Project: Hiniker Parkway and Park Parking Lot	City Project No.: 11206 (Parkway) & 11207 (Parking Lot)
Contractor: Dirt Merchant, Inc. (DMI)	Date of Contract: April 13 th , 2026

Description: The Hiniker Park Parking Lot (11207) project requires changes to the contract as noted below, for additional scope of work and to reconcile added materials not included in the project bid unit prices and quantities as noted below.

CITY OF
MANKATO
HINIKER POND
PARK PARKING
LOT

UTILITY PLAN

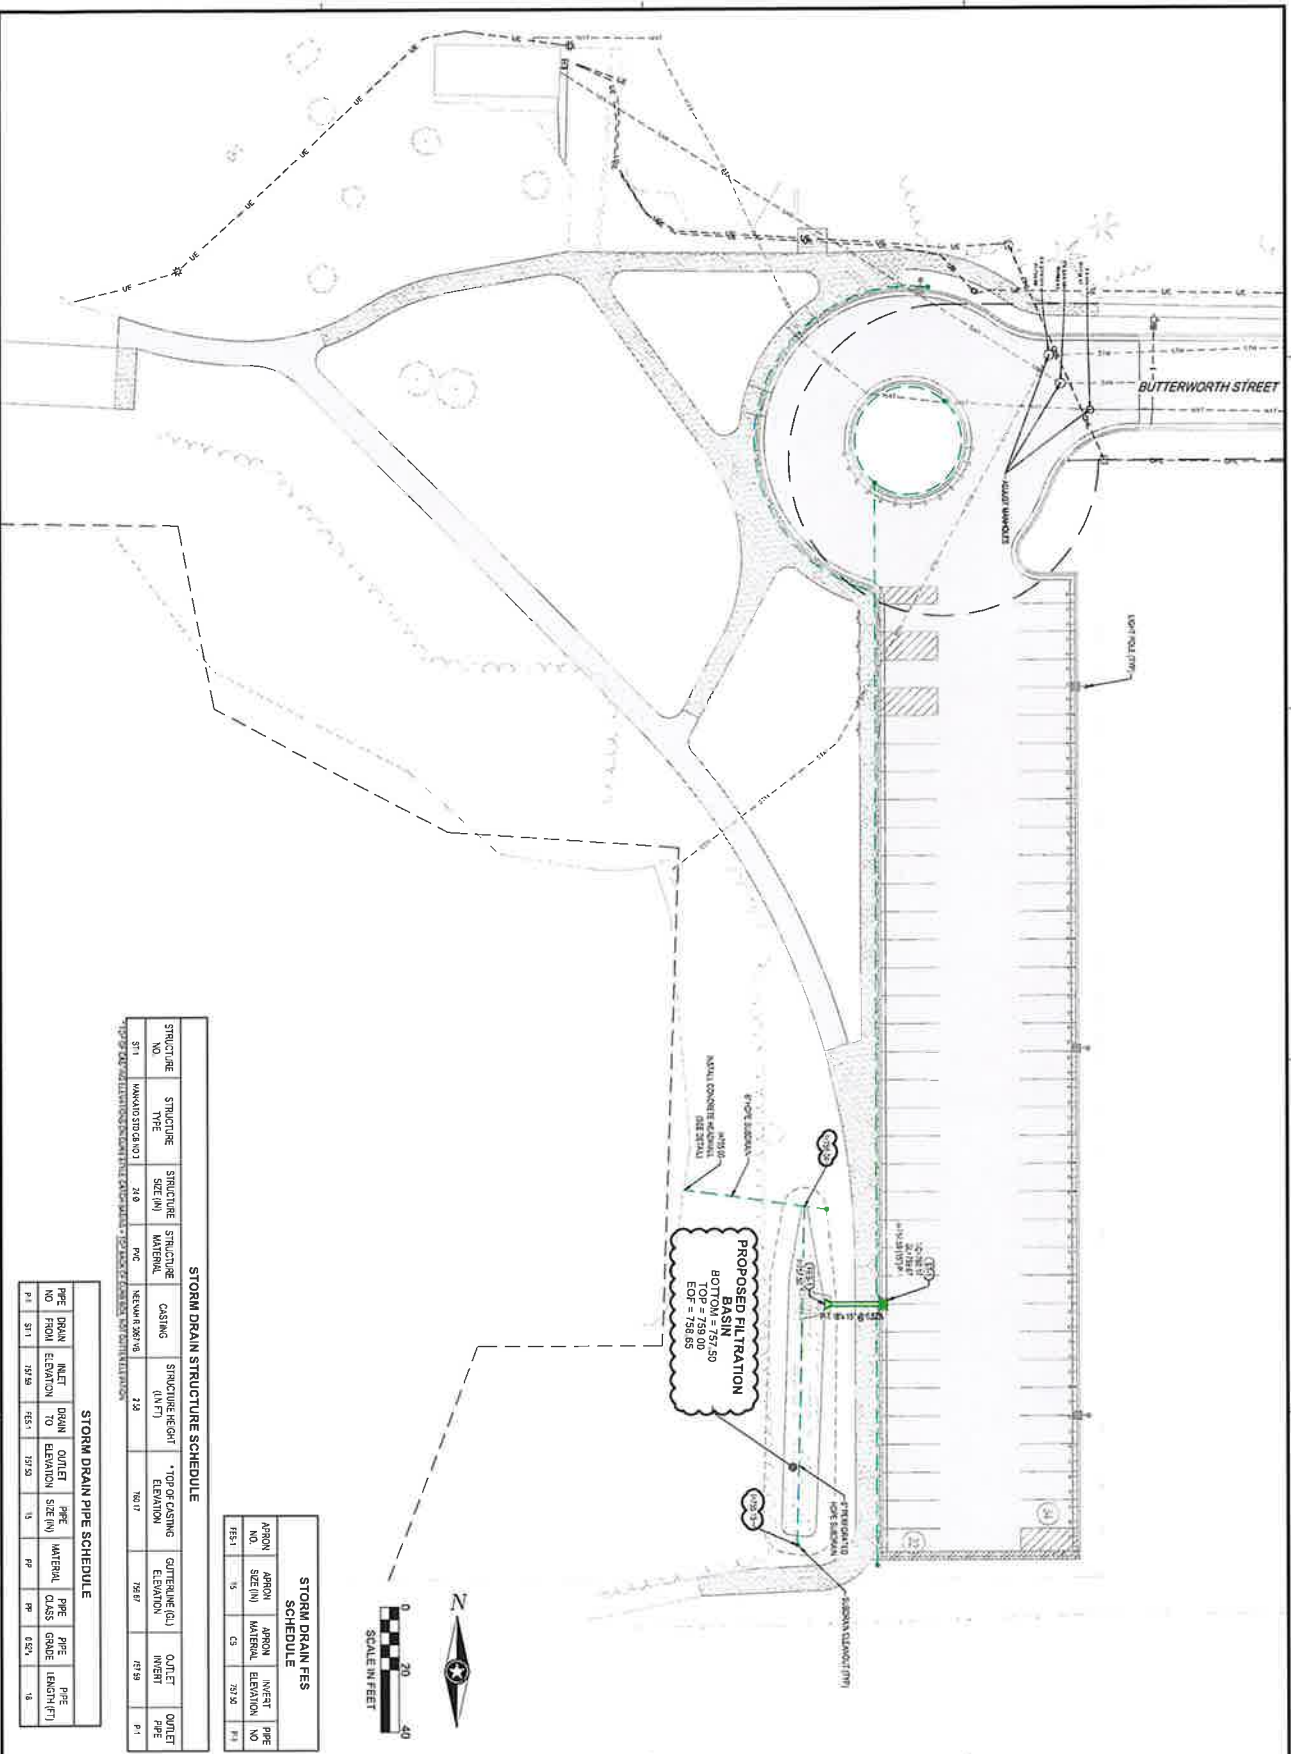
Filtration basin filter media material is to be added to the project bid form, for the stormwater basins. These quantities were not included in the project bid form, but they are required to complete the work as planned. See attached revised plan sheets with quantities/material callouts.

Pond stabilization improvements to the discharge pipe and overflow locations were proposed to the parking lot stormwater pond, to better fit field conditions. Riprap will be added to these locations for energy dissipation during rain events.

Subdrain cleanout castings were shown in the plans as Sch-40 PVC threaded caps. These were changed to meet the city standard plate detailed cast iron casting/lid combination. The additional material cost for these castings will be added for each unit installed.

ArcGIS Web Map

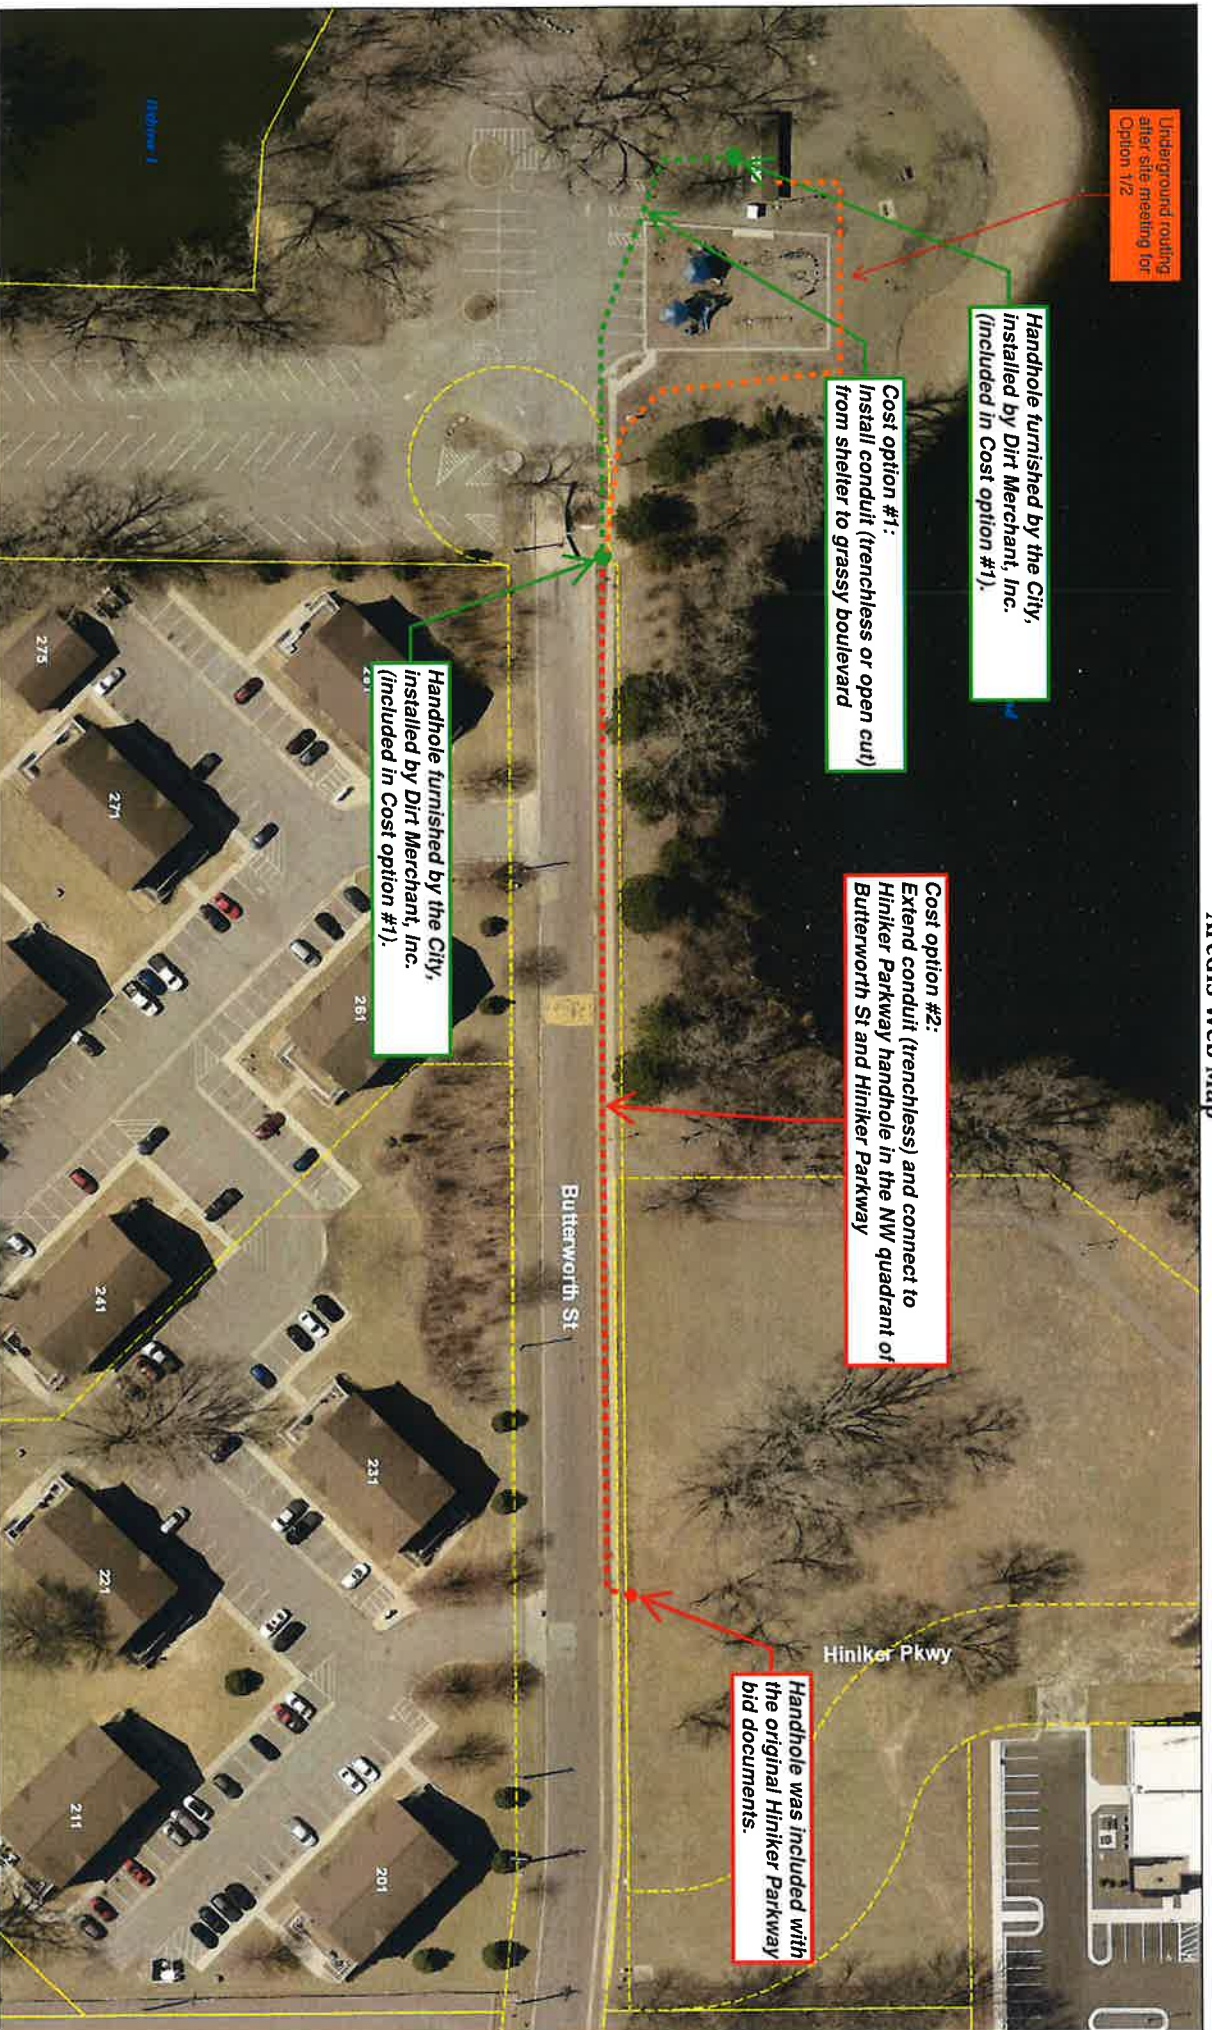
Additional conduit is being requested by city staff to provide a location for future fiber communications improvements planned in the area. This conduit is an added item to the contract. See attached pricing and map figure for additional information related to lengths and location.

Electrical - Additional Mobilization, Install City provided FO Vaults, Directional Drill 1-1/2" HDPE Conduit to Hiniker Park Shelter from New Handhole on New Hiniker Parkway project. **Per Foot Price includes contractor provided conduit Length TBD \$20/LF (725 LF estimated). Pricing assumes (2) FO Vaults, and (1) additional mobilization fee.**
